MECKLENBURG COUNTY
DEPARTMENT OF ENVIRONMENTAL HEALTH

MECKLENBURG COUNTY
DEPARTMENT OF ENVIRONMENTAL HEALTH
INSTALLATION, CONSTUCTION, ALTERATION, AND/OR REPAIR PERMIT
(Individual Septic Tank System with Subsurface, Soil Absorption, Effluent Discharge)

CERTIFICATE OF COMPLETION

Location of Property 21320 MAYHEW RD

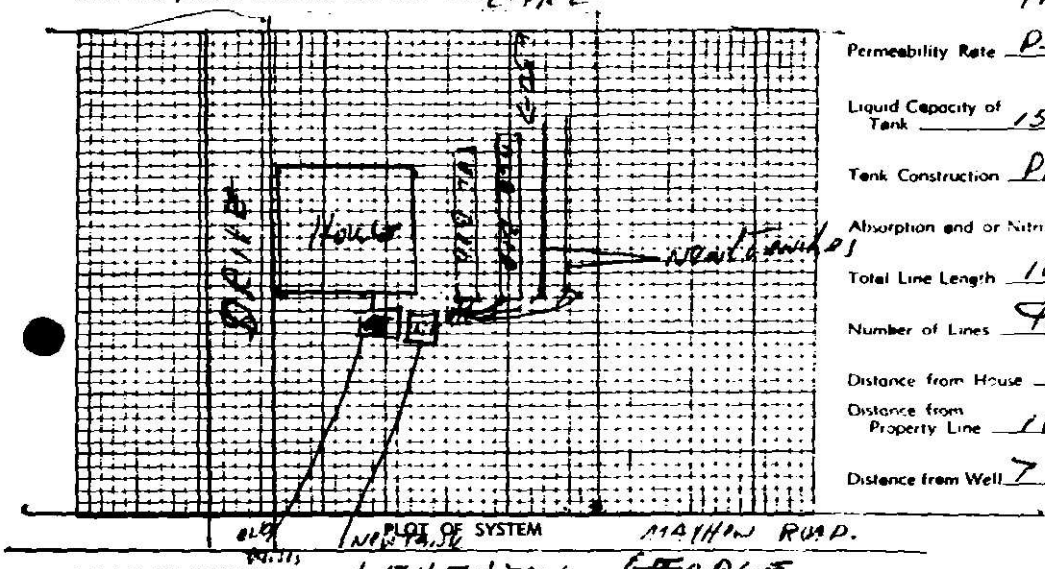
NEW TANK IF LOWER THAN DIST BOX OR DRAINFIELD - AND TWO TRENCHES 50FT X 3FT x 18 inches STONE - AND DIST BOX

Comments Repair changed from two trenches - 18" stone & one 34 FT trench 36 in bes stone & tied to existing field that had never been hooked up since ~~[illegible]~~ tree roots had cut them off
